**GREAT LAKE TAUPŌ**

Taupō District Council

## Property File

2013-08-19 Request for information - A1149970

ISSUE	AMENDMENT	DATE	Sheet number:	Issue:
			A05	A
			Project number:	213015

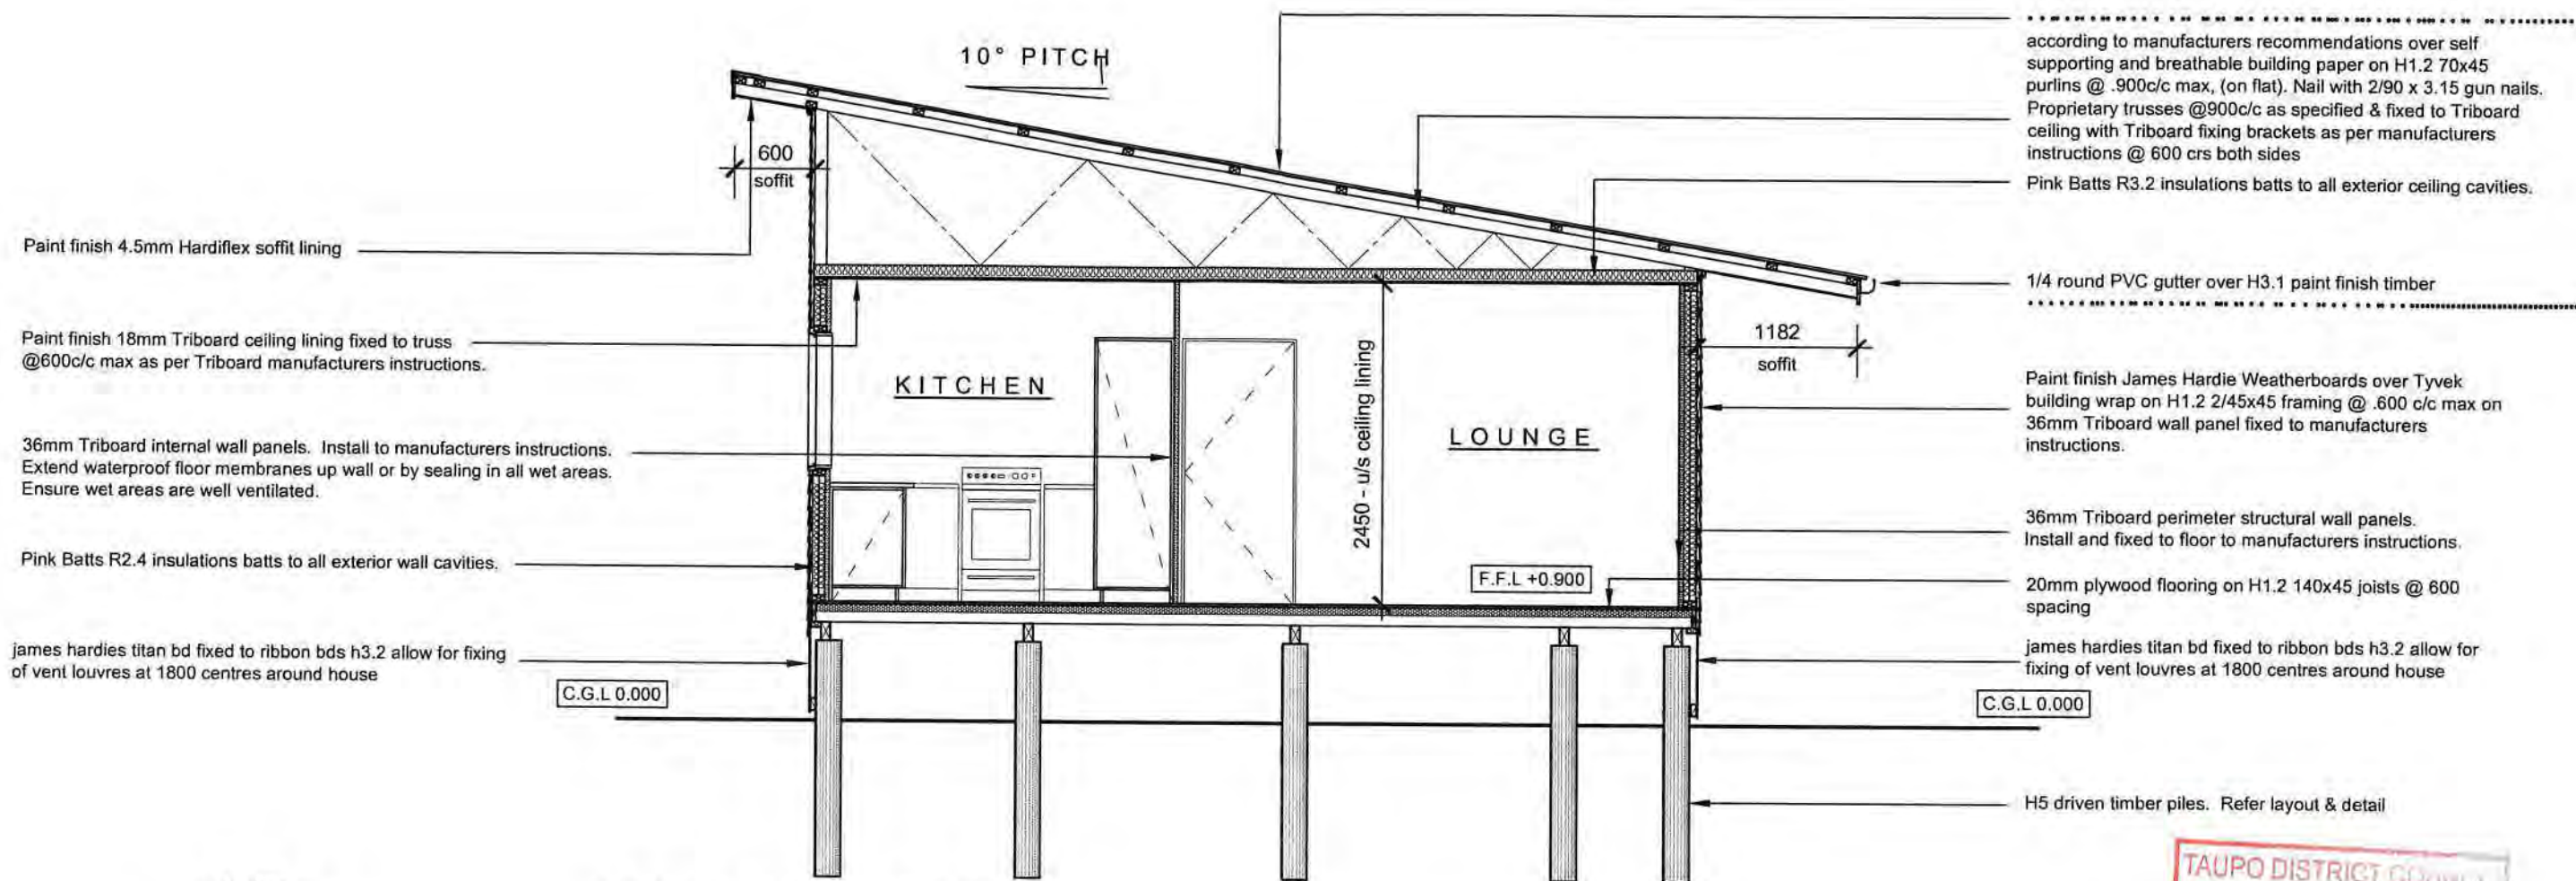
- 5. On the cross section there has been a problem with the printing which has deleted some notes. Please update page A06.**
- 6. Please show access to the building. There is a 100mm concrete patio noted on the floor plan with nothing to support it or any construction details. Show how this interacts with the timber floor. Please show position of steps on the floor plan. Riser and tread sizes need to comply with Clause D1 so please show them. Also if there are over three risers, a handrail needs to be shown complying with Clause F4.**

**EXTERIOR WALL TO FLOOR FIXING DETAIL**  
Scale 1:10 on A3

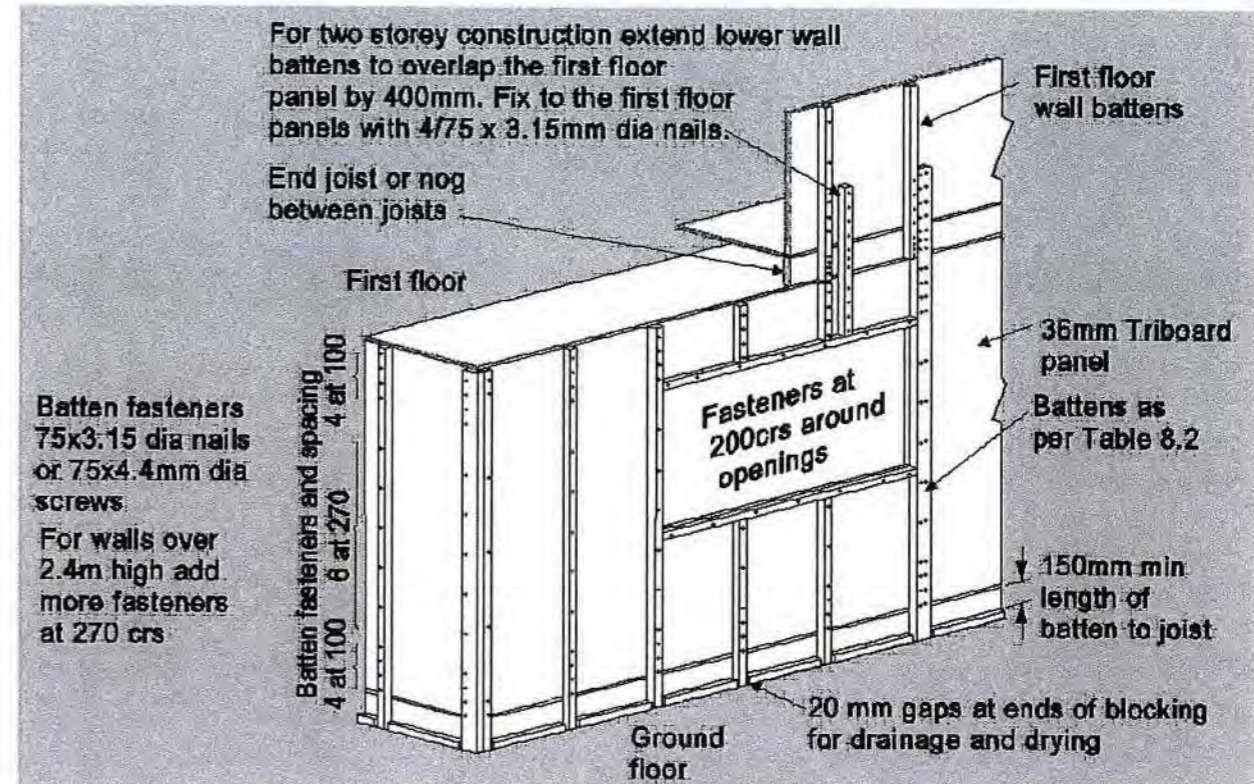
- 2. A detail has been provided for the bottom plate fixing to concrete floor. Please modify this detail to show a timber floor as this is not site specific.**

Figure 10.2 - Roof truss connection to walls

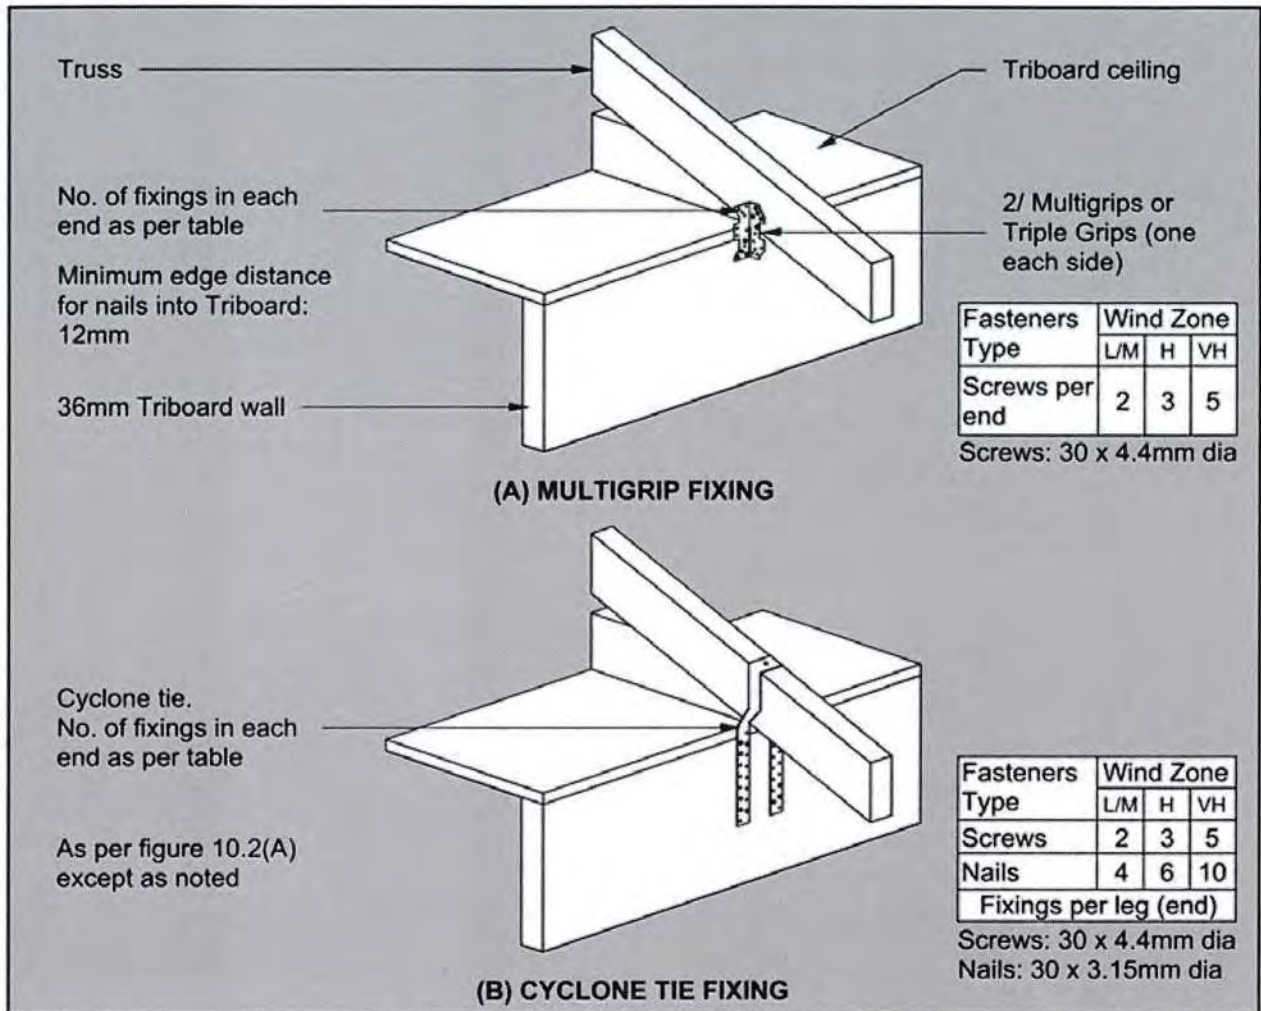
- 3. Please show how the trusses are to be fixed to the wall framing showing compliance with Clause B1.**
- 4. Please confirm lintel sizes for all openings. If not required due to construction method, please provide manufacturer's documentation showing this. Also note on the plans which measurements relate to lintel size.**

- 1. The pile connection still refers to NZS3604, please specify exactly what the fixings are.**
- 2. I have a ceiling to truss fixing detail but I still don't have a detail for the truss fixing to the wall.**
- 3. When the cross section is converted to PDF at this end some of the script is incompatible, hence the notes on the cross section are still not coming through**
- 4. The site plan still shows the stormwater connecting to the existing system. There is no existing system. As per the PIM conditions the stormwater needs to go to soakholes or otherwise be contained onsite.**
